Public Comment for the Southwest Light Rail Transit Supplemental Draft Environmental Impact Statement

Re: Response to Metropolitan Council's Southwest Transitway Supplemental Draft
Environmental Impact Statement

Twin Cities & Western Railroad Company Response to Metropolitan Council's Southwest Transitway Supplemental Draft Environmental Impact Statement

Comments Submitted by the Minneapolis Park & Recreation Board in Response to the Supplemental Draft Environmental Impact Statement for the Southwest Light Rail Transit Project

Figure 1 – Hopkins Operations and Maintenance Facility Location

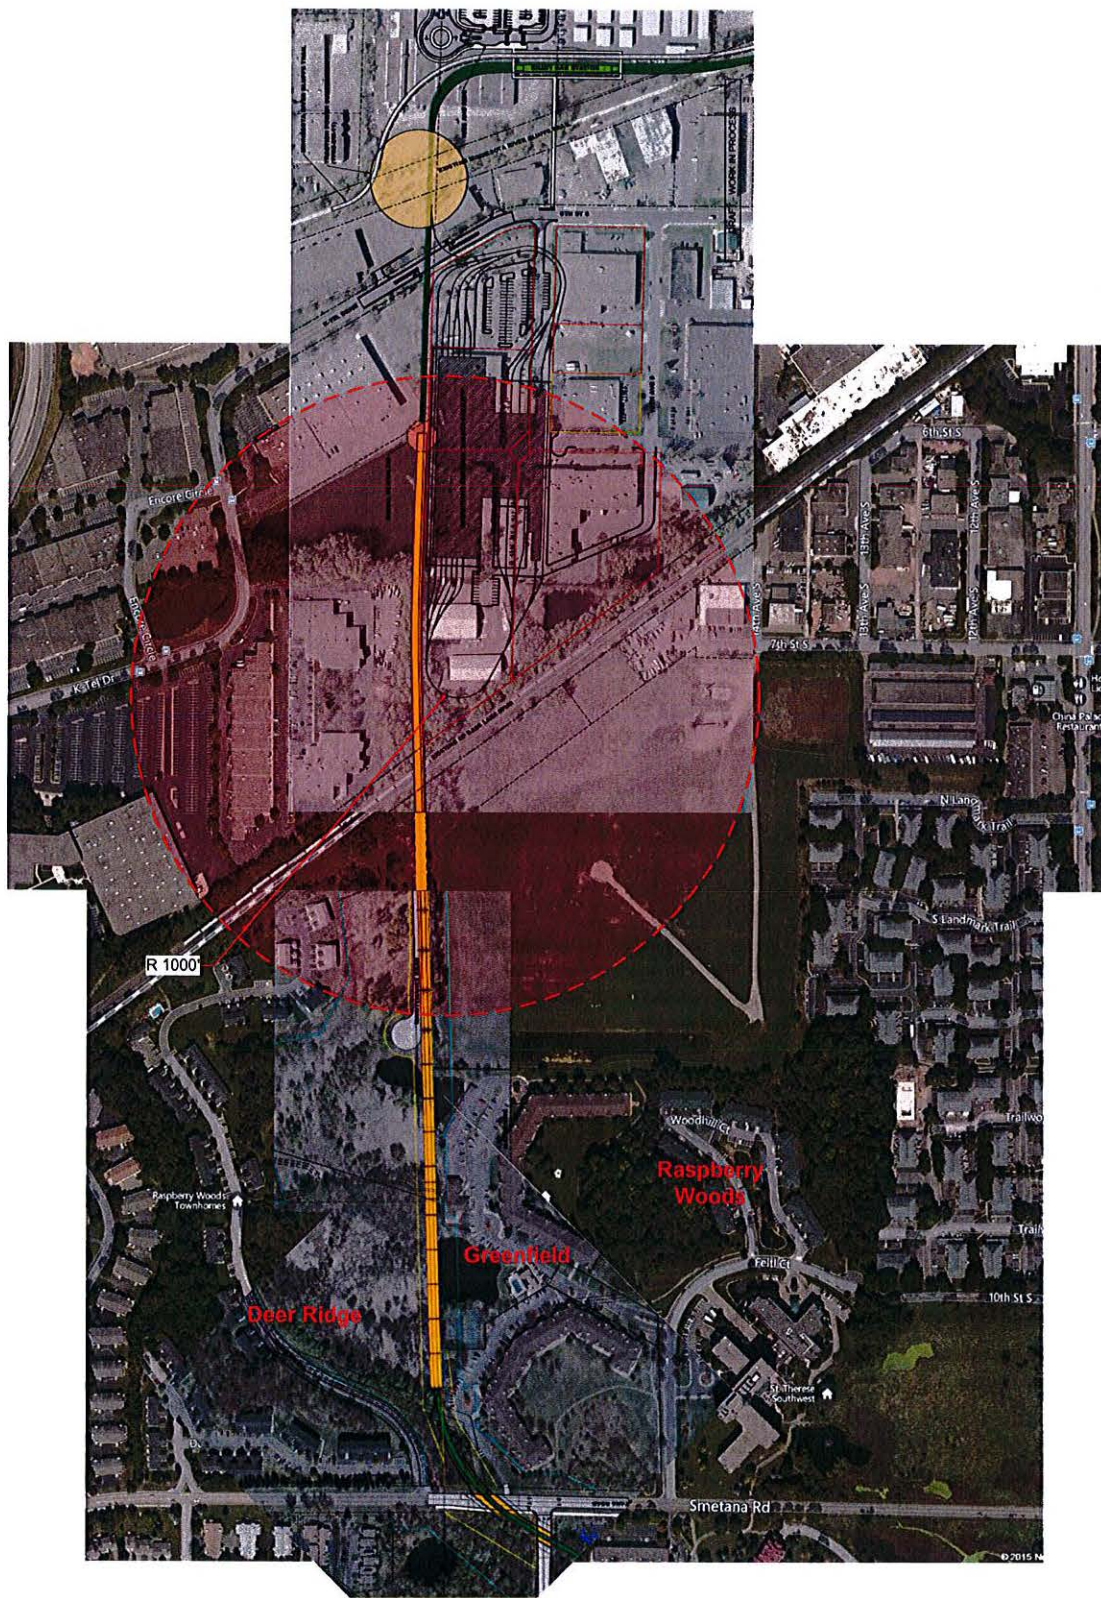
Figure 1 shows the location of the proposed Hopkins Operations and Maintenance Facility (OMF) in comparison to nearby StuartCo properties. In the review of possible environmental categories effecting OMF sites, several categories were dismissed for review for Site 9A, Hopkins K-Tel East. These dismissed categories include noise and vibration impacts. According to the FTA guidelines in the 2006 Transit Noise and Vibration Impact Assessment document, the screening distance required for noise assessments from "yards and shops" is 1000 feet. Figure 1 shows a circle with a radius of 1000 feet with a center at a point on the south end of the proposed Hopkins OMF site location. Multiple StuartCo residential units fall within this area, with the closest unit being approximately 750 feet from the proposed Hopkins OMF. Clearly a noise impact assessment will be needed per the FTA requirements and none was done. Noise from the OMF will also need to meet the MPCA requirements, which may be more restrictive.

Figure 2 - Elevation of track in SDEIS Appendix F

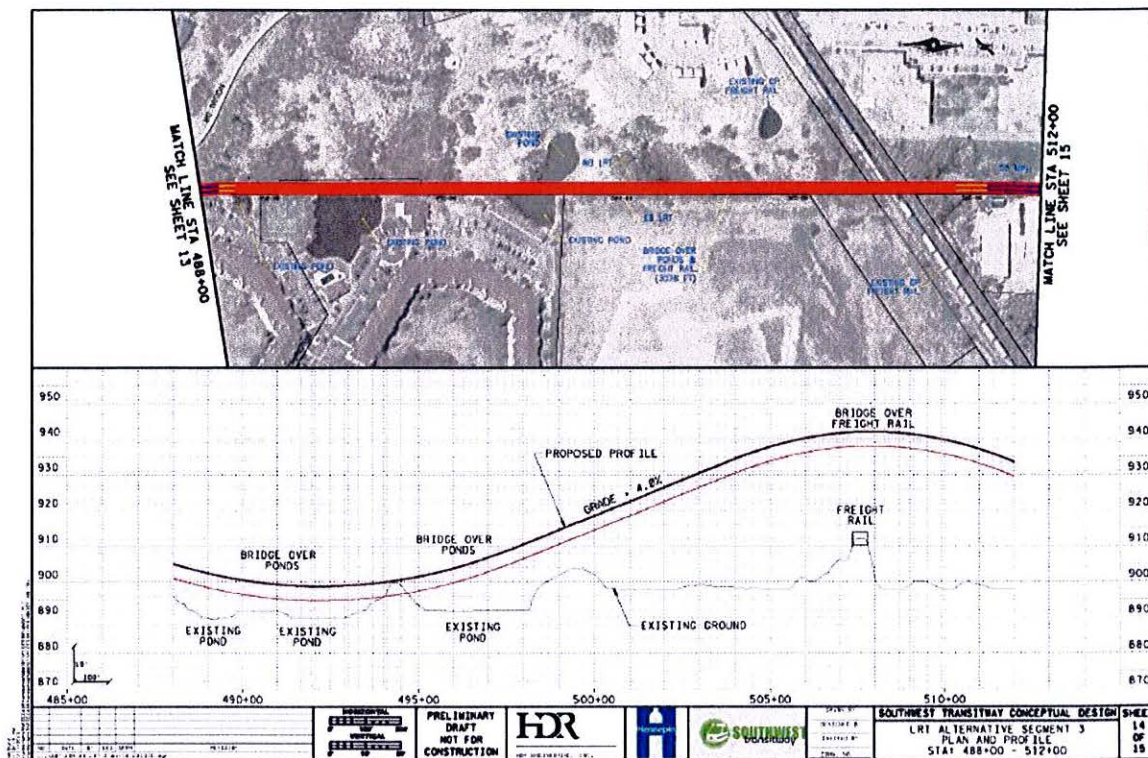
Portions of the track nearby StuartCo properties are proposed to be elevated on bridges due to ground conditions and ponds. When track is built on an elevated structure rather than on ground, there is potential for additional structure-borne noise. This additional impact has not been addressed in the noise assessment for this area. Figure 2 shows the elevated track near the StuartCo properties. The effects of the elevated rail structure should be included in the impact assessment.

Diagram A – Existing sewer force main at approximately 22 feet below grade obstructs planned location of SWLRT south tunnel in the Kenilworth Corridor, which requires an estimated 45 feet below ground level for construction pit and helical piles.

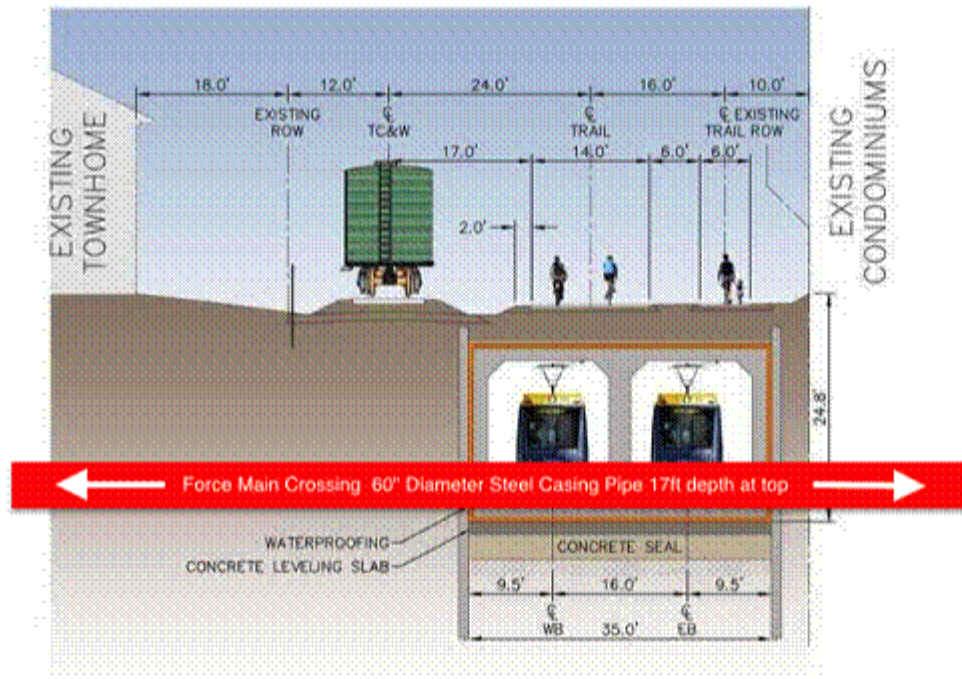
Short term vibration impacts – Effects of construction activities and, to a lesser extent, construction vehicles will have an impact on park users, neighbors and their residences. Vibration and associated ground-borne noise impacts may damage walls, ceilings and foundations of nearby residences, as was experienced in the original construction of this force line. Mitigation plans/cost are not included in the SDEIS and need to be addressed.
